Response to s92(1) request – Discharges to Air Allied Asphalt Manufacturing Plant

Allied Asphalt Limited (Allied) lodged an application with the Bay of Plenty Regional Council (BoPRC) for resource consent in December 2022, for activities associated with its asphalt plant located at 54 Aerodrome Road, Mt Maunganui.

- Resource consent application RM22-0649 – to discharge contaminants to air, disturb contaminated land, undertake earthworks and discharge stormwater – Request for further information, 08 February 2023

Figure 2.1: Sprinkler location plan, existing site (Source: Allied)

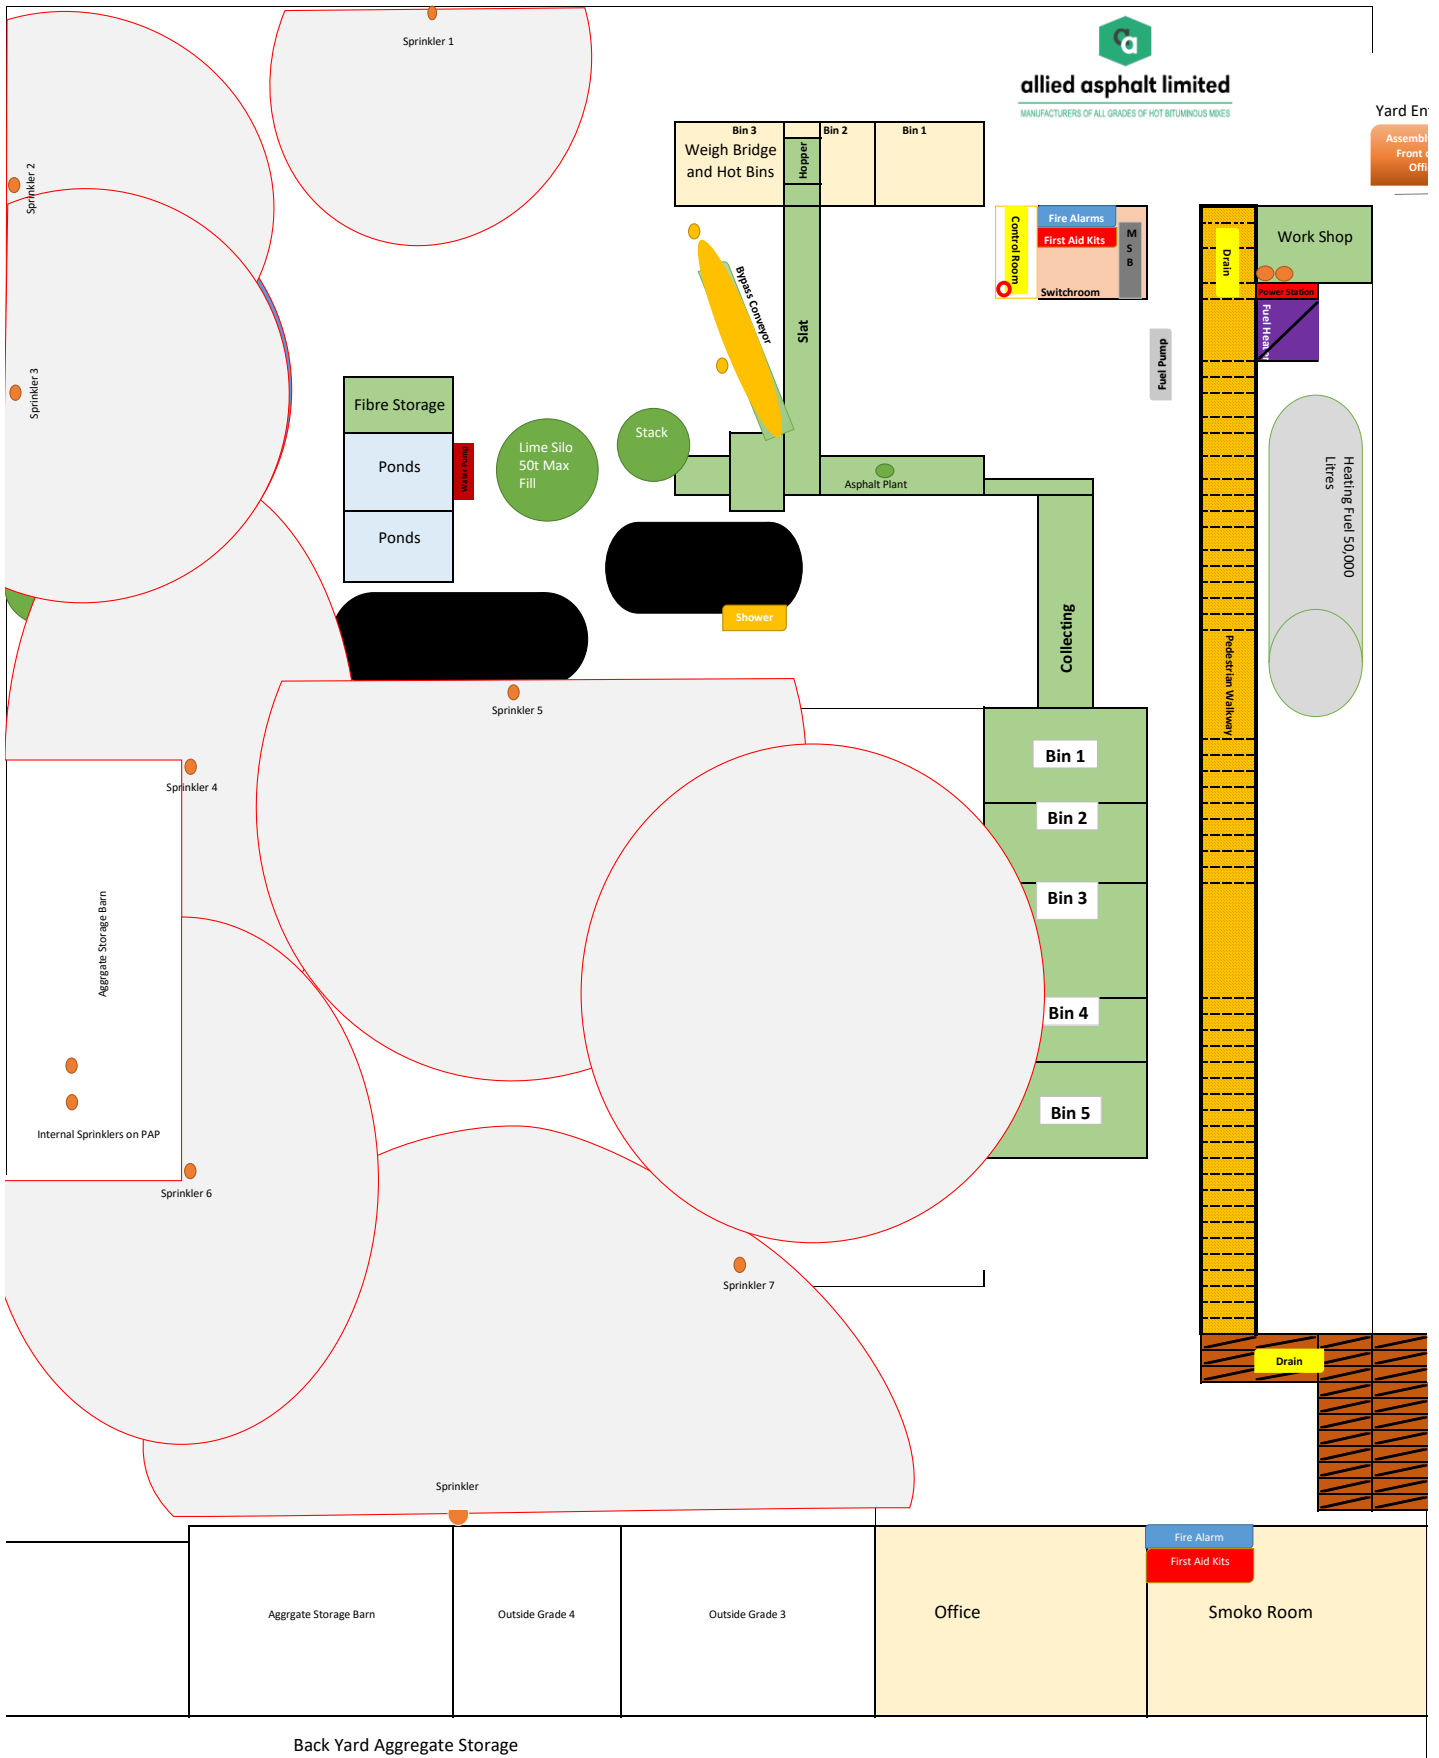
| 1 | Can the applicant provide more information around the details of the recycled dust suppression (sprinkler) system used to reduce entrained dust around aggregate storage and handling areas. |

Allied has provided a plan of sprinkler head locations at the existing site, which is provided in **Figure 2.1**. Rainwater is collected from the roof of the covered aggregate bays on the site's western boundary and stored on site in a 30,000 L tank. An additional 30,000 L tank is proposed to be installed at the upgraded site. Allied will have the capability to refill these tanks with mains water in the event of extended dry spells.

The final sprinkler layout for the yard is still being finalised, but will be designed to provide sprinkler cover for all areas that will be subject to aggregate handling activities and will include dampening for the fine aggregates in the covered storage.

Figure 2.3: Bitumen tank venting waterbath system engineering drawings
Source: Fulton Hogan

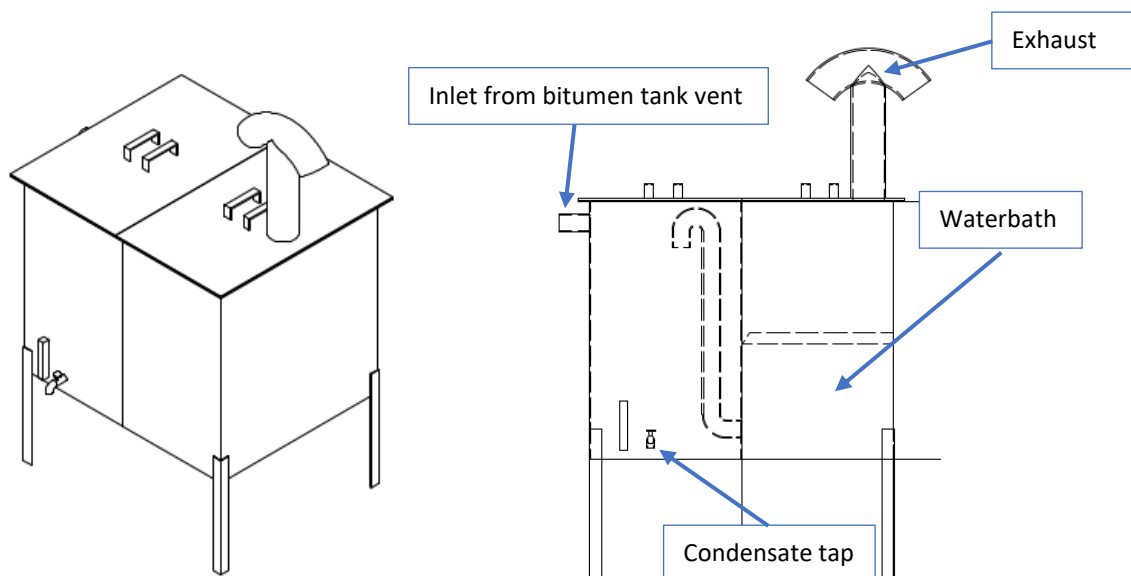
2 Please provide more information around the effectiveness of the water bath system used to remove odour.

Allied has referred to examples of water bath systems used at similar plants operated in Australia and New Zealand, an example of which is illustrated in **Figure 2.2** and **Figure 2.3**.

The heating of bitumen in the storage tank releases a small amount of semi-volatile organic compounds from the light end hydrocarbons. These cool when emitted to the atmosphere and condense to form the characteristic 'blue smoke'. The proposed water bath system is used to cool the displaced airstream from the bitumen tack vents and retains the condensate and light oils before the air is emitted.

Allied report that these systems are widely used in the industry as effective and easy to maintain odour management measures.

Figure 2.4: Maximum 24-hour average PM₁₀ concentration contour plot for the proposed plant (pink cross indicates the proposed stack, light blue squares are sensitive receptors) Aerial imagery: Imagery was captured for BOPLASS Ltd by AAM NZ Limited

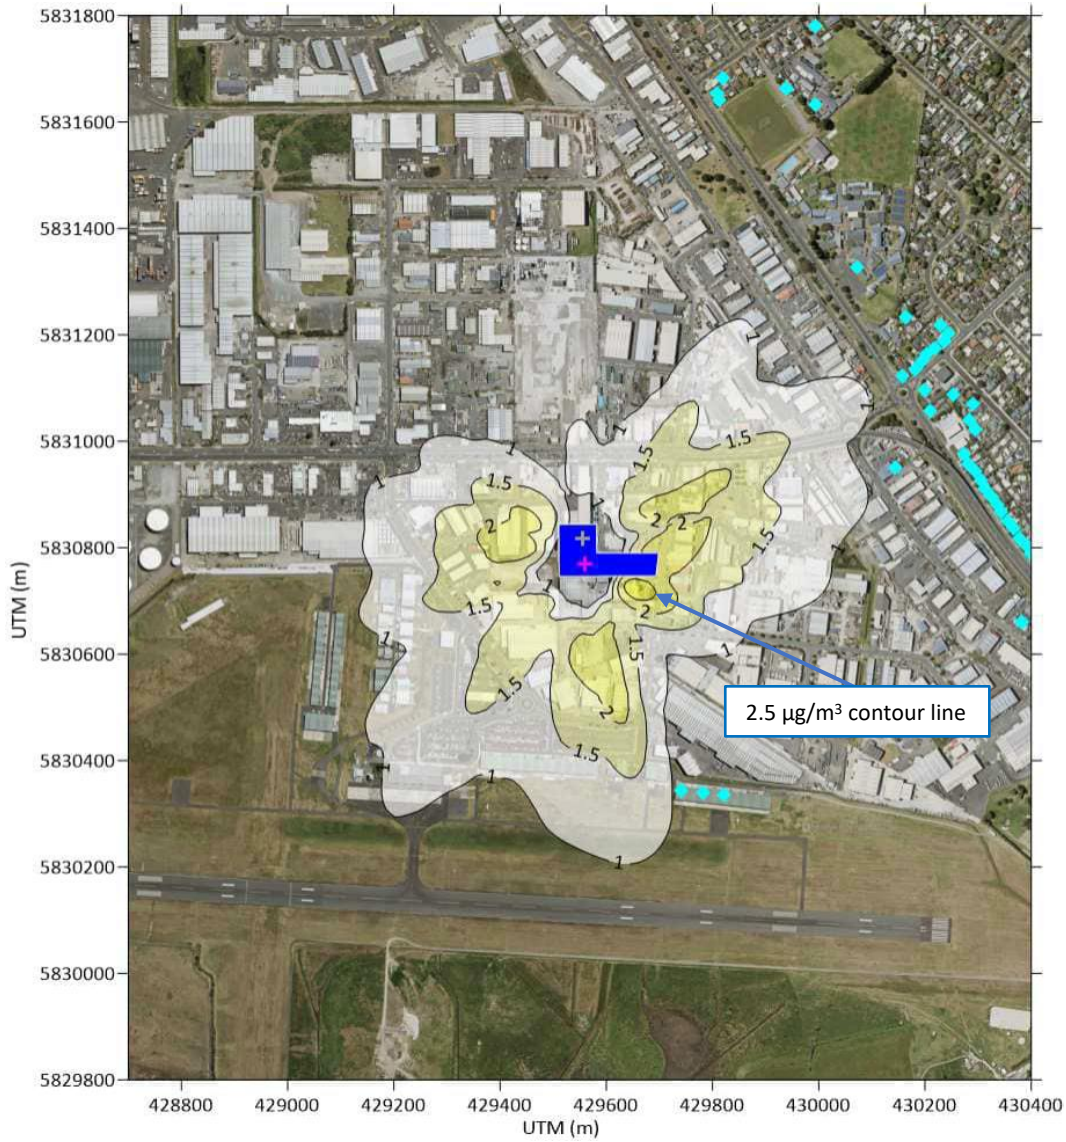
- a. The new plant will increase in PM₁₀ by more than 2.5 µg/m³ in the airshed. The applicant needs to provide confirmation of the MGLC in the Airshed.
- b. Provide the contour map for the current plant for 24-hour average PM₁₀.
- c. Calculations in Table 7.1 (page 47) state an emission rate of 1kg/hr from the proposed plant, however, elsewhere an emission rate of 1.25kg/hr has been stated (which is equivalent to 30mg/m³). Confirm which is to be used and recalculate where the incorrect emission rate has been used.

- a. As stated in Section 7.1 of the AQA, the peak modelled off-site 24-hour average PM₁₀ MGLC from the proposed new plant is 2.8 µg/m³, which is predicted to occur southeast of the site boundary on the adjacent HR Cement site (over a bulk tank). The 2.5 µg/m³ contour covers a portion of the HR Cement site and is not predicted to be exceeded on any other neighbouring properties, as shown on **Figure 2.4** below.

The effect of the overall proposal, which is to cease operating the existing asphalt plant once the proposed plant is commissioned, is to reduce PM₁₀ emissions into and concentrations within the airshed. This can be seen by comparing the predicted PM₁₀ concentrations for the existing plant in **Figure 2.5** (addressing b. of this question) with that of the proposed plant in **Figure 2.4**.
